Creak From Seat Riser Mechanism –  
Front Seat Frame

MODEL 1997-99 MY  
XK8 Range

VIN 001001-031345

Remove and destroy Bulletin 910-07, dated 3/99.  
Replace with this Bulletin.  
Revisions are marked with a bar and in **bold text**.

ILLUSTRATION 1

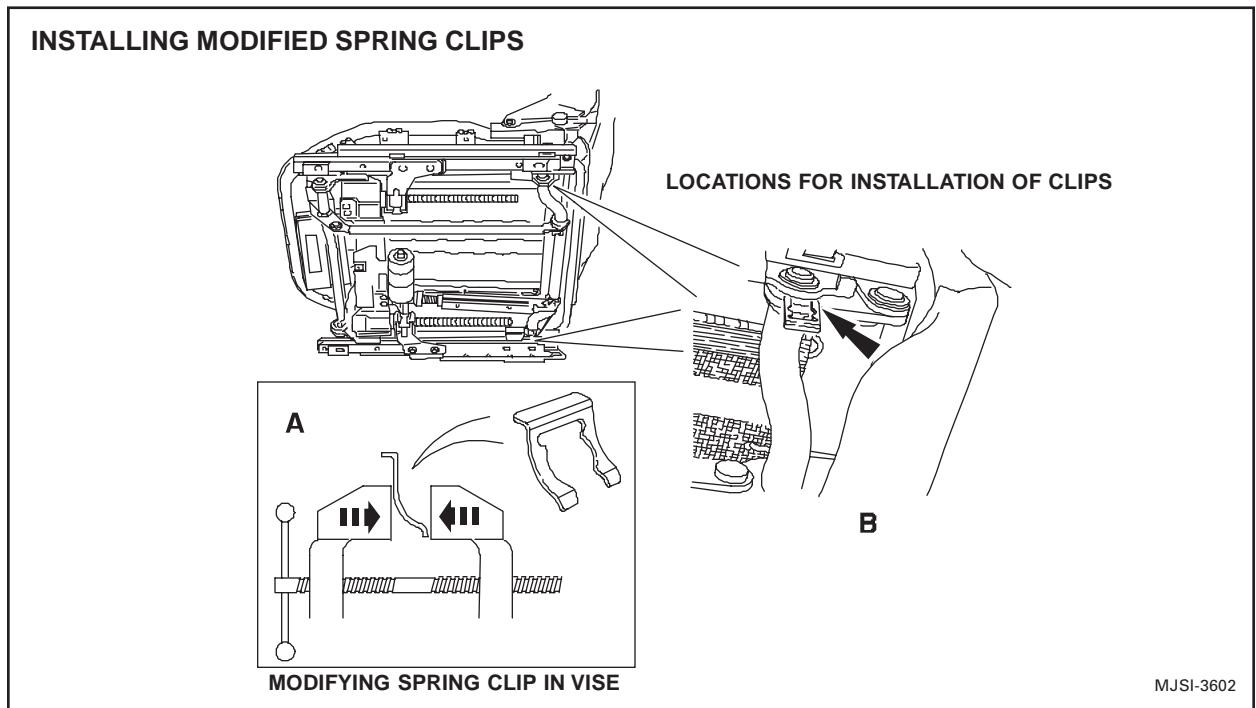
Some XK8 vehicles within the above VIN range may experience a ‘creak’ from a front seat which may be caused by end-float of the rear riser bar of the seat riser mechanism. This bulletin provides a procedure to insert spacers at each end of the rear riser bar.

From VIN 031346 an O-ring has been installed in the same location to minimize end-float of the riser bar.

1. Flatten the curved portion of each of 2 spring clips, by inserting the curved portion of the clip between the open jaws of the vise and then closing the vise firmly. (A, Illustration 1). Note that the small ‘tab’ on the clip, at right angles to the curved portion, should remain above the

vise jaws during the above procedure, so that the right angle bend is not affected.

7. Insert the modified clips in the gaps at the two locations shown as B in Illustration 1. Use a small hammer to tap each clip home until its cutout fully engages with the seat riser bar.

In case of a customer complaint **only**, on an XK8 vehicle within the above VIN range, modify 2 spring clips, Part No. AGU 2722, and install them in the seat riser mechanism as described below.
